IMPORTANT SAFETY RECALL

NHTSA Recall No. 24V-526

SAFETY NOTICE

SUBJECT: Replacement Basket Bracket

Figure 1. Compatible Components - Original basket bracket and original basket bracket retaining pins
In production from 7/21/2014 through 7/30/2020

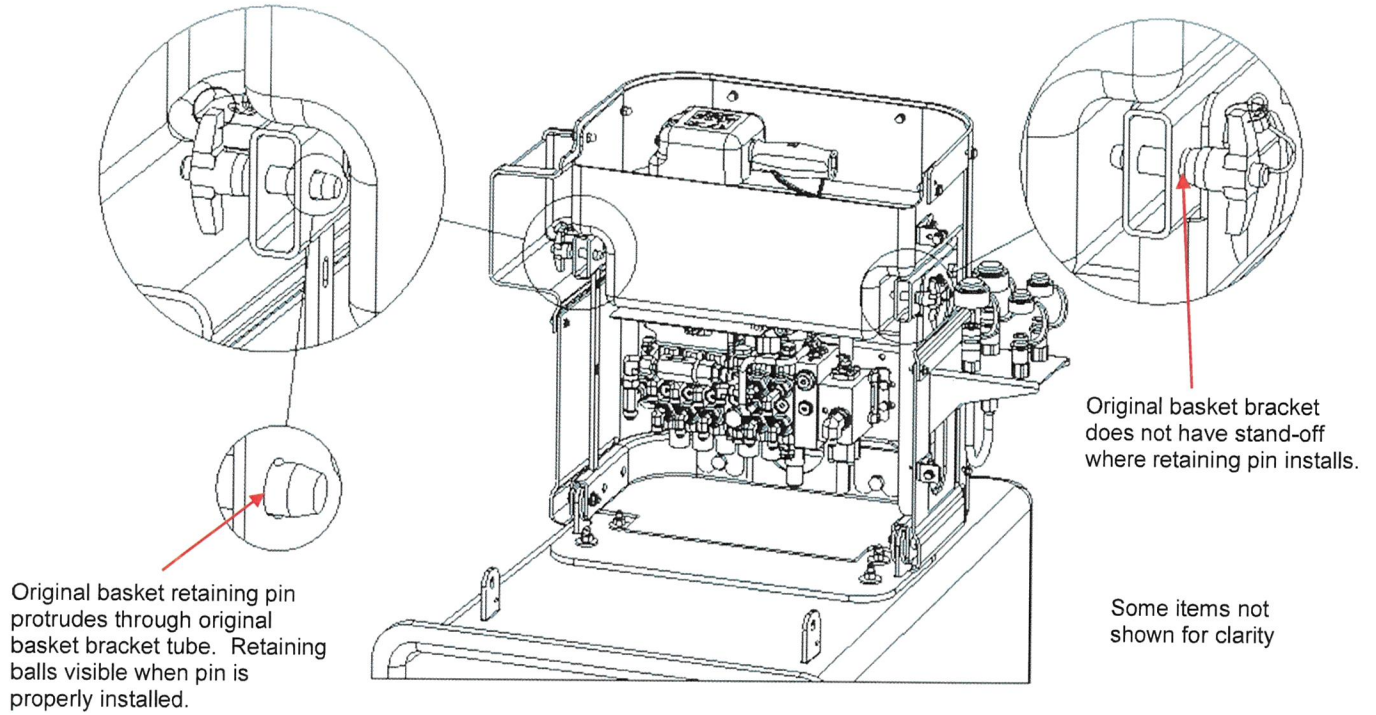
1. Immediately inform all users, operators, and supervisors of the contents of this bulletin.
2. Before the next use of the aerial device, inspect for compatibility of the basket bracket and the basket retaining pins using Figures 1 through 4 at the end of this bulletin as reference. Each basket retaining pin must extend through the basket bracket tube and the pin must have a method of retainment when the pin is fully installed such as retaining balls or secondary locking pins.

Figure 2. Incompatible Components - Replacement basket bracket and original basket bracket retaining pins

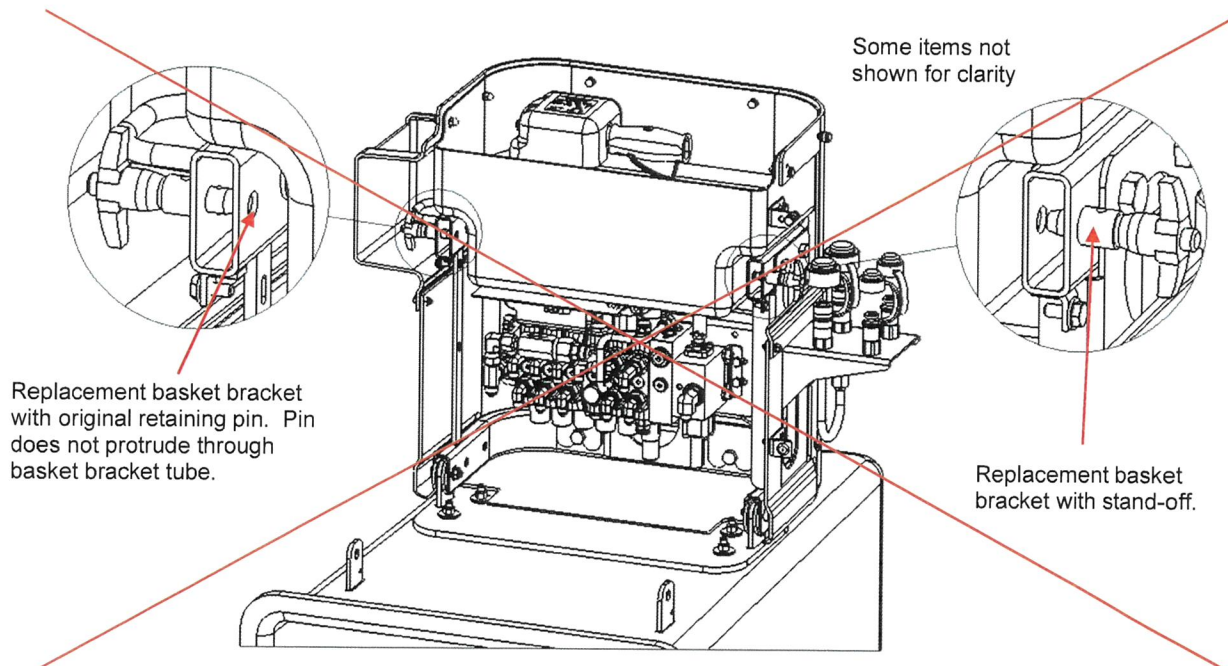
The new style replacement basket brackets as noted above may not be compatible with the original basket retaining pins on models manufactured prior to August 2020. **If both basket retaining pins disengage, the basket may tilt which can cause personal injury to the occupants of the basket.**

Terex will provide Field Service Kit Z1724, parts and labor, at no cost to the purchaser of the replacement brackets. The Field Service Kit Z1724 provides basket retaining pins and hardware to replace the original basket retaining pins. The remedy will take approximately one (1) hour to complete.
